Science and Technology Shortfalls in the National Missile Defense Program

Theodore A. Postol
Professor of Science, Technology, and National Security Policy
Security Studies Program, Massachusetts Institute of Technology
Voice: 617 253-8077; FAX: 617 258-5750; e-mail: postol@mit.edu

Washington, DC
Thursday 1 March 2001

The Baseline Algorithm

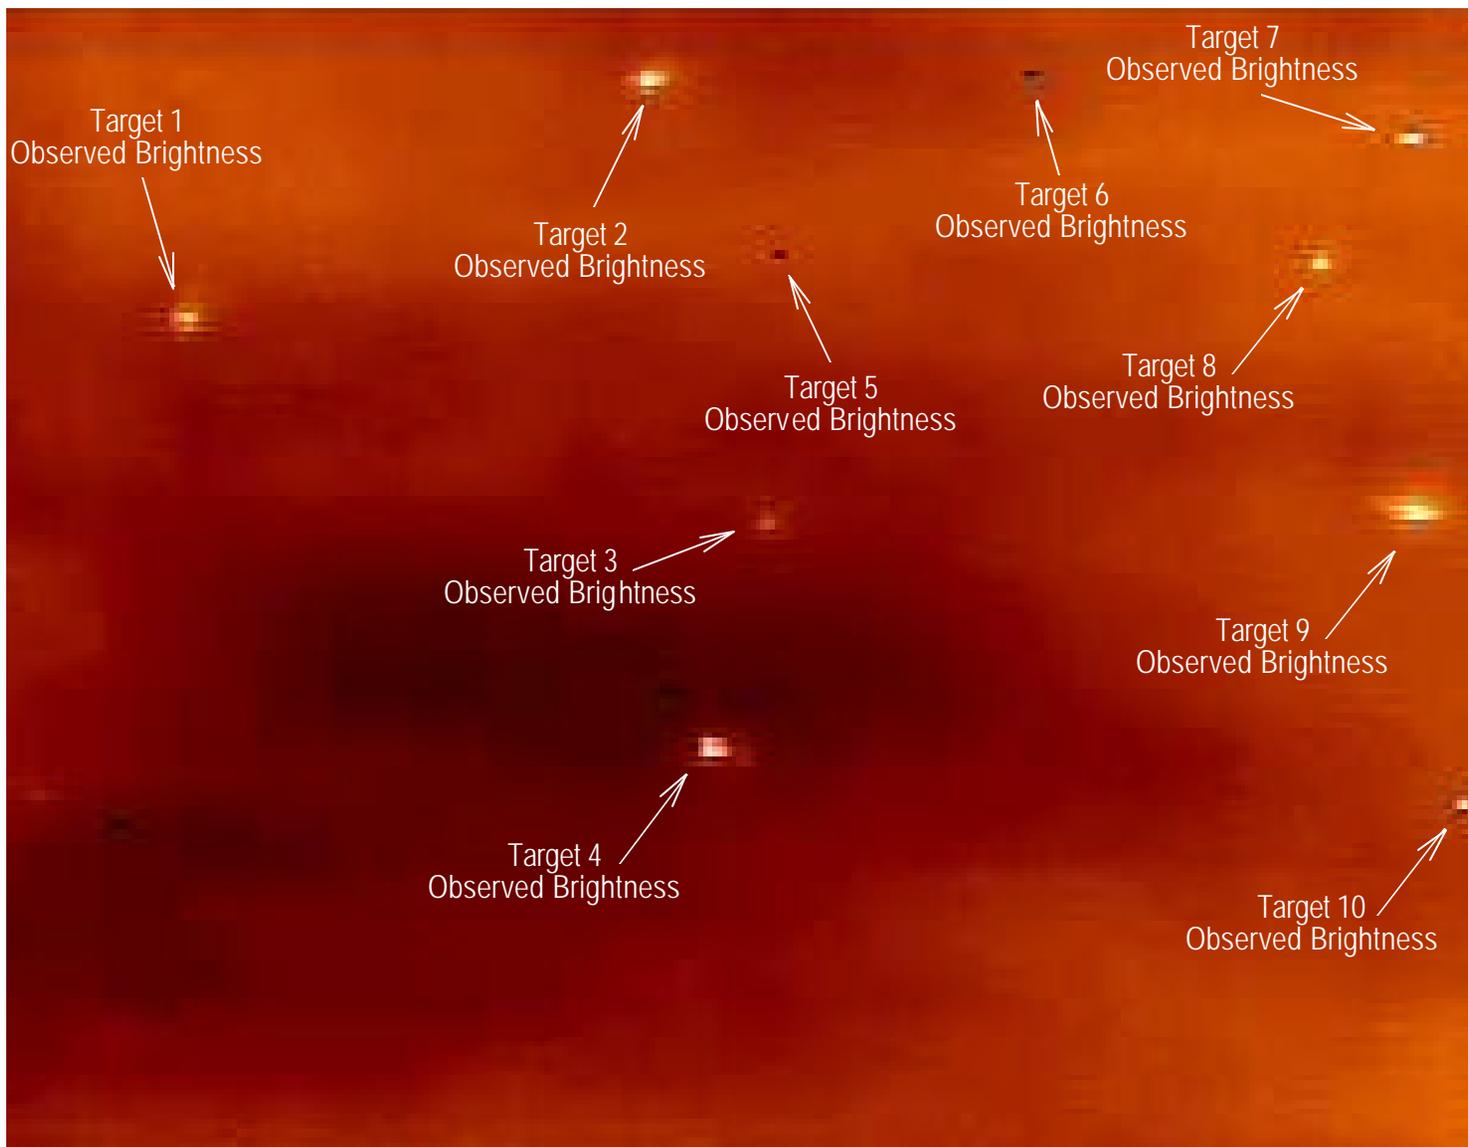
Requires Prior Knowledge
of the Signal Intensities
and the Fluctuations in Intensities
from the Warheads and Decoys

Fails Because

Measured Target Intensities Did Not Match the Predicted Intensities
and

Observed Average Target Intensities Were Unstable in Time
(Signals were Non-Stationary)

How the Ellipses Used in the Baseline Algorithm Were Generated

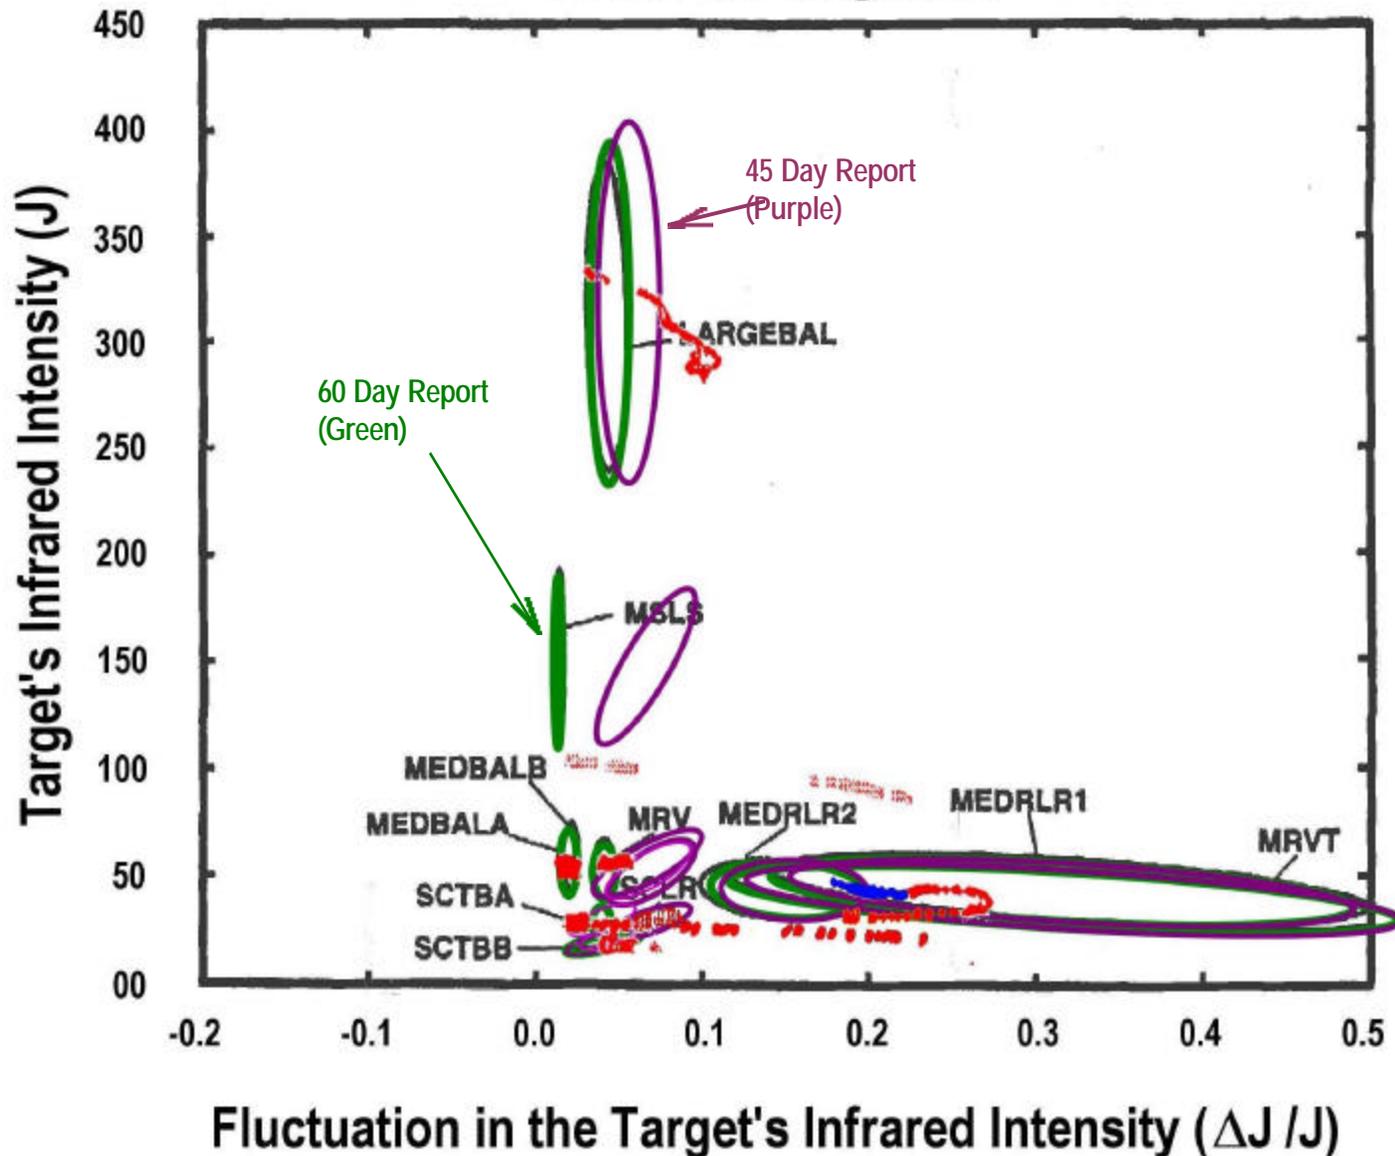
Requires Prior Knowledge of the Target Structure, Shape, Environment, and Dynamics

Fails Because

Unexpected Deviations in Target Dynamics, Structure, and possibly the Space-Environment are Not Captured in the Calculations

Solution to Problem

Construct the Ellipses Used in the Baseline Algorithm by Matching Them to the Observed Data
(That is, Move the "Bulls Eye" to Where Hits Occurred)

Discrepancies in One- σ Ellipses in the 45 Day Report with the Ellipses in the 60 Day Report

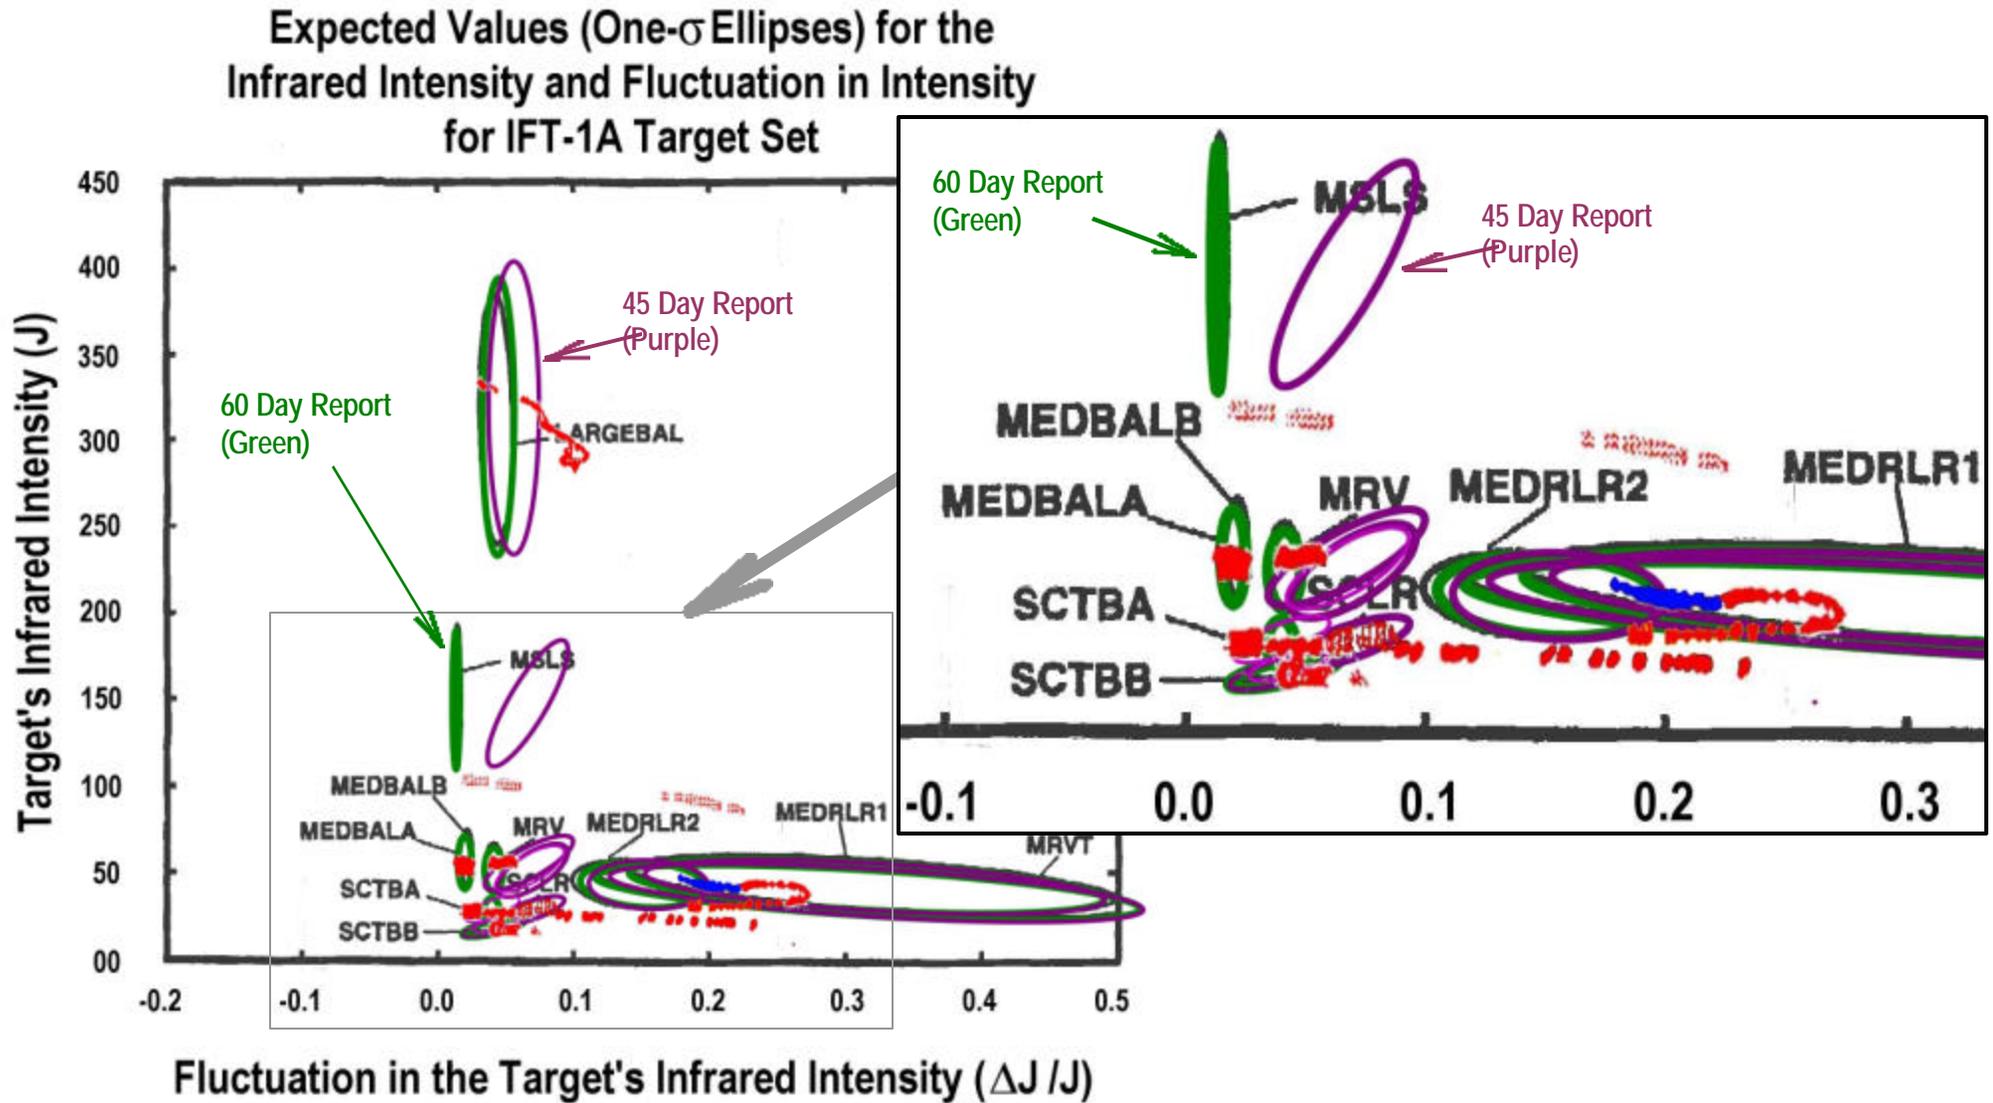
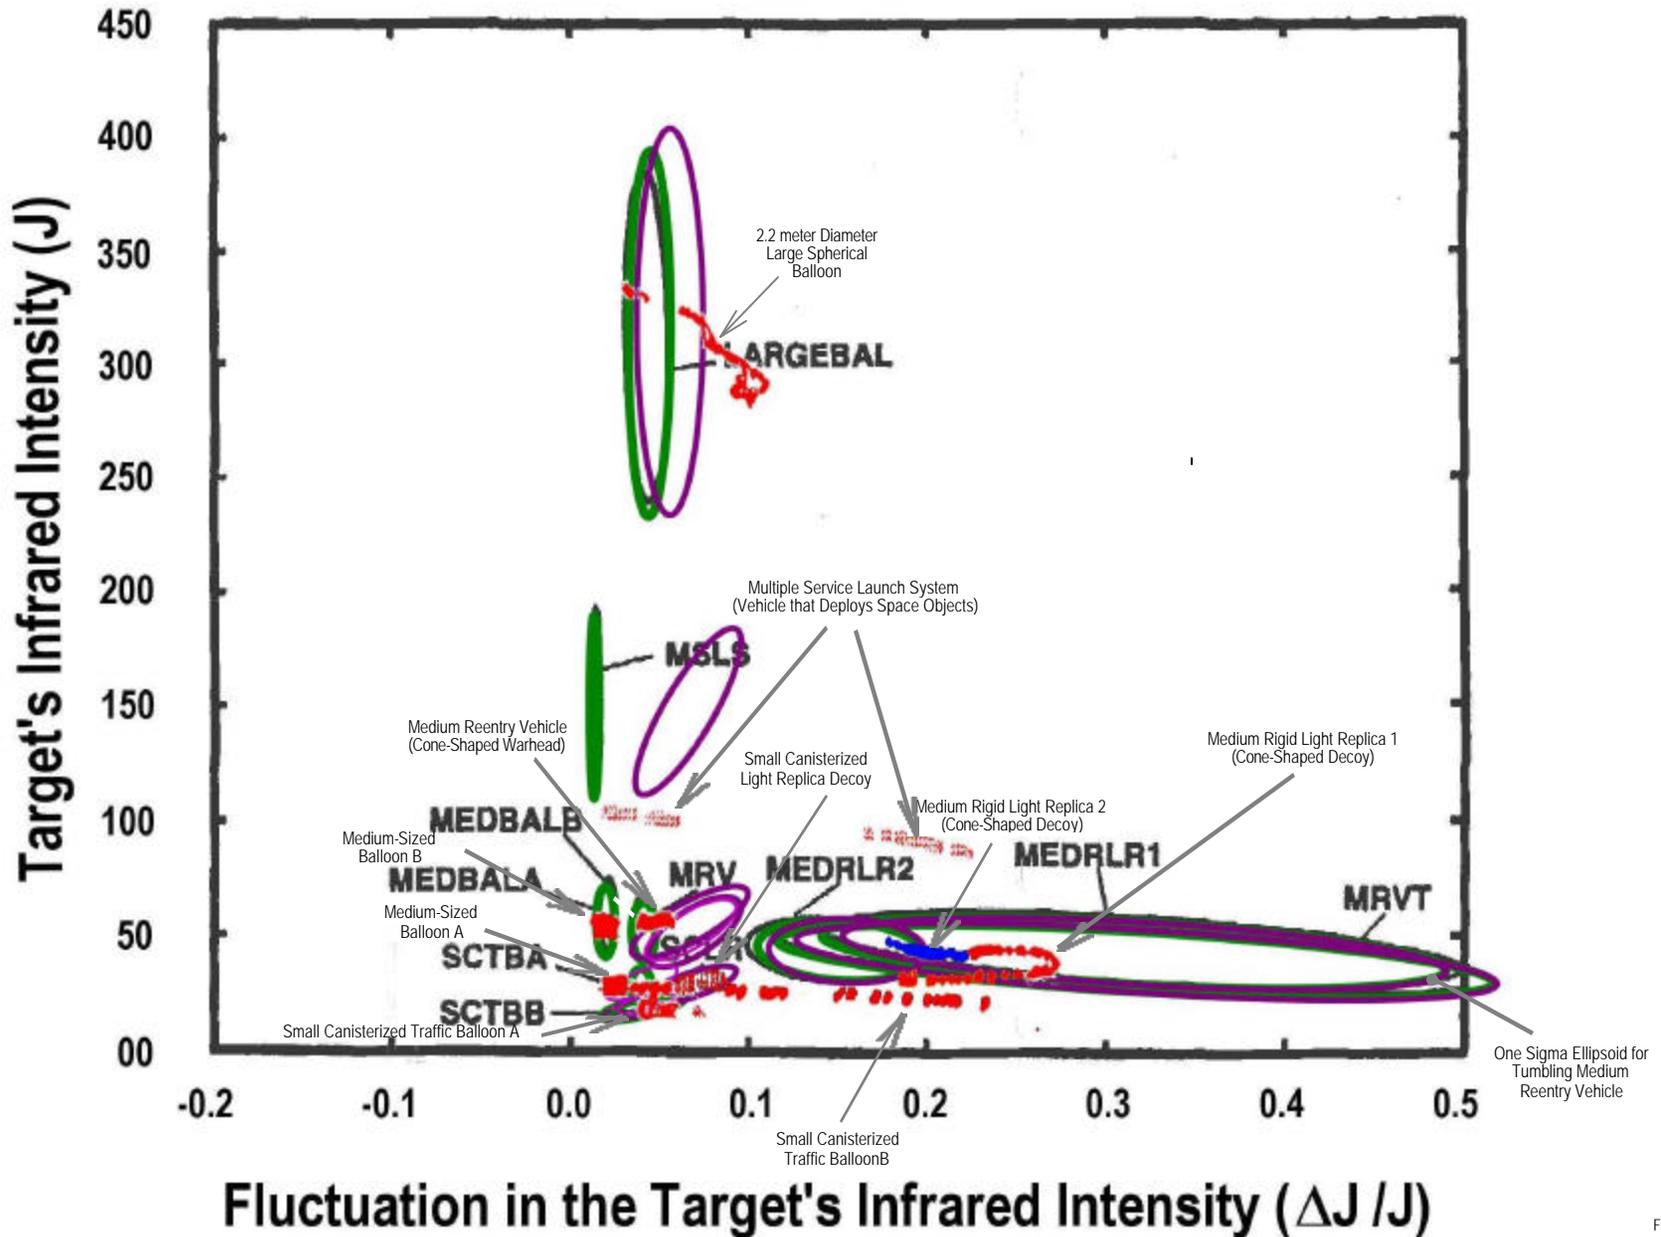
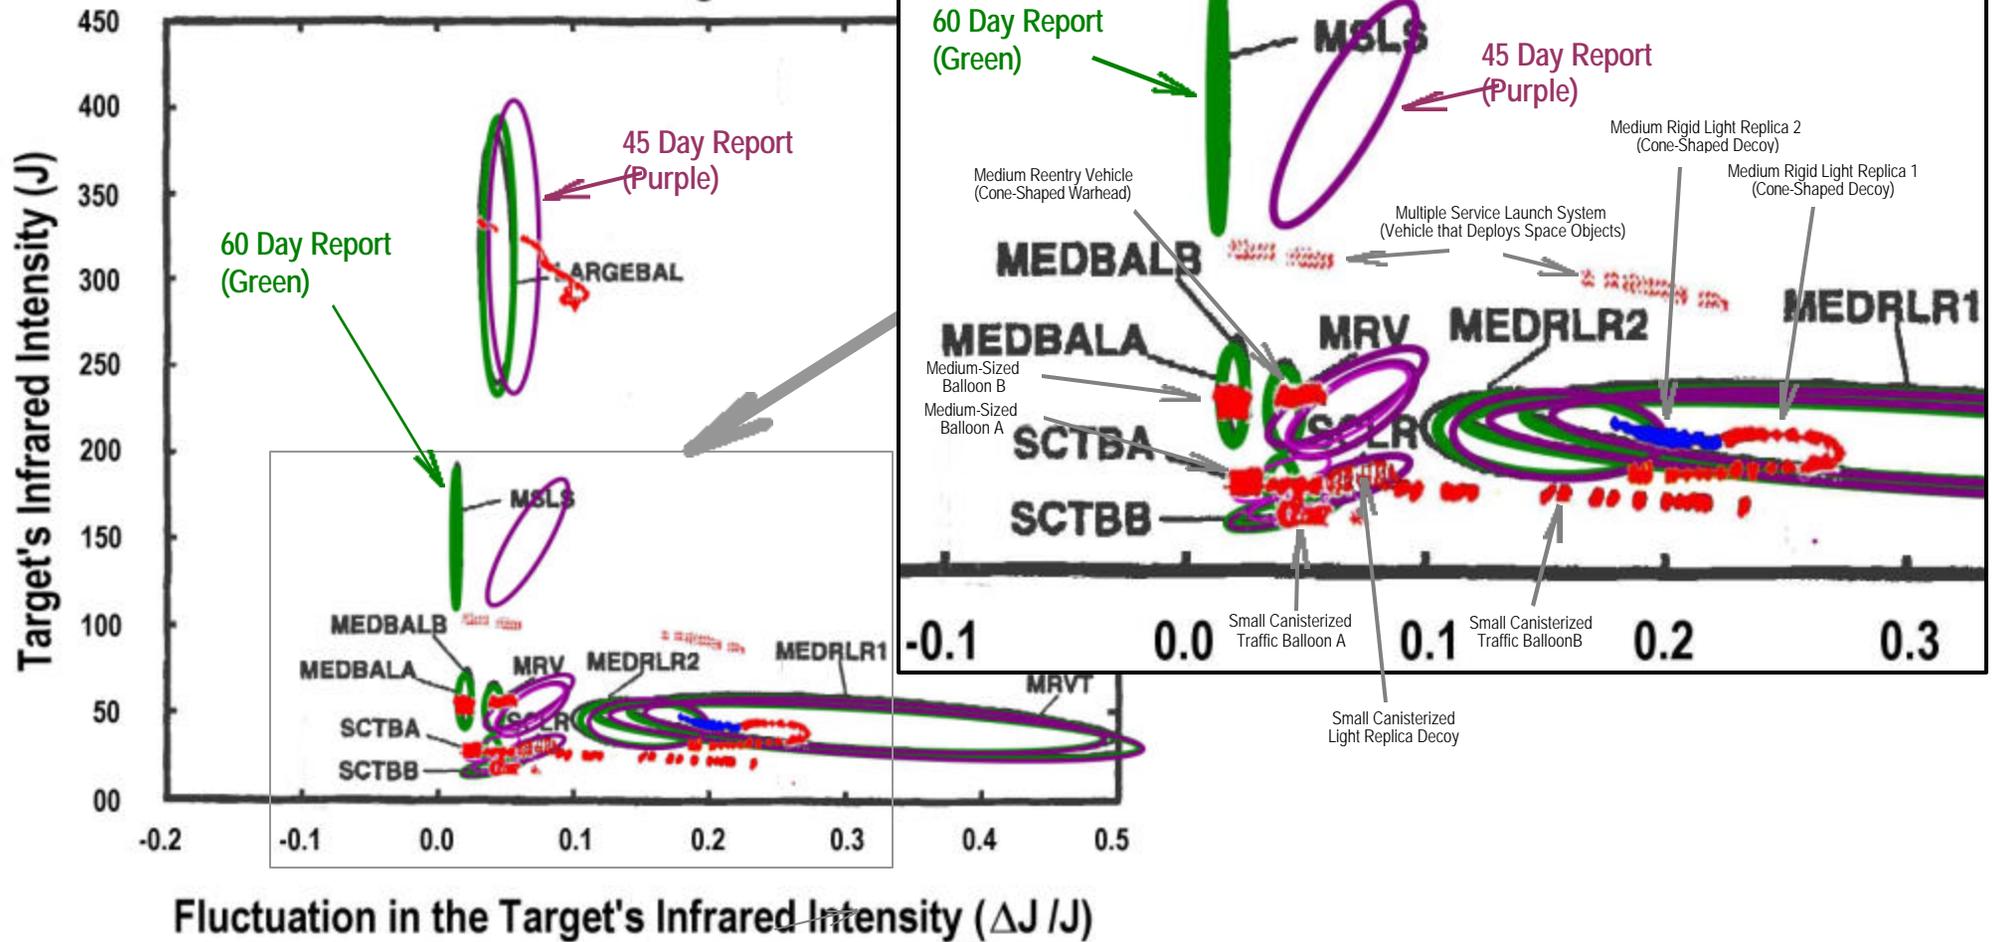
Estimated Identities of Targets Based on Observed Data, Expected Values, and One-Sigma Ellipses

The Kalman Filter

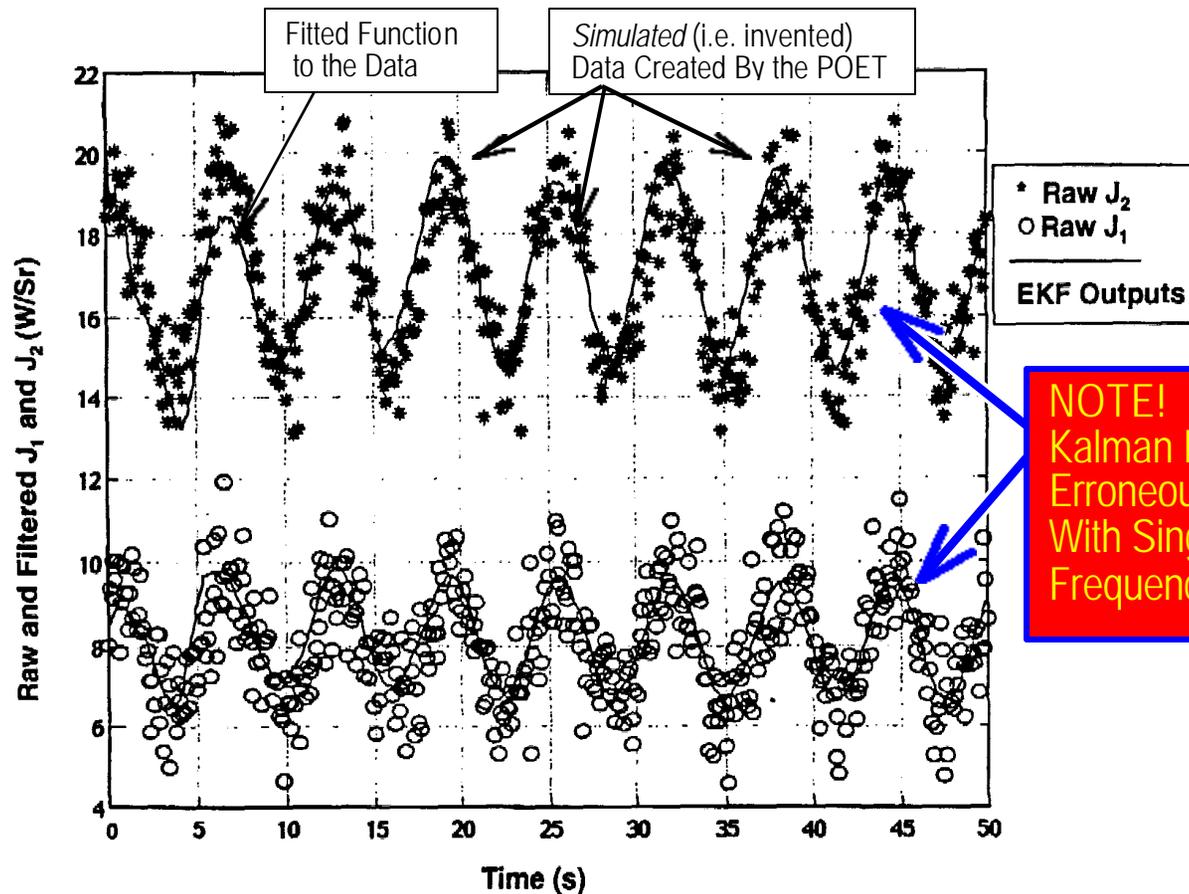
Fails to Extract Features Because
the Filter **Assumes** that the Target Signals Contain Only **One** Frequency
When They Instead Contain Multiple Frequencies
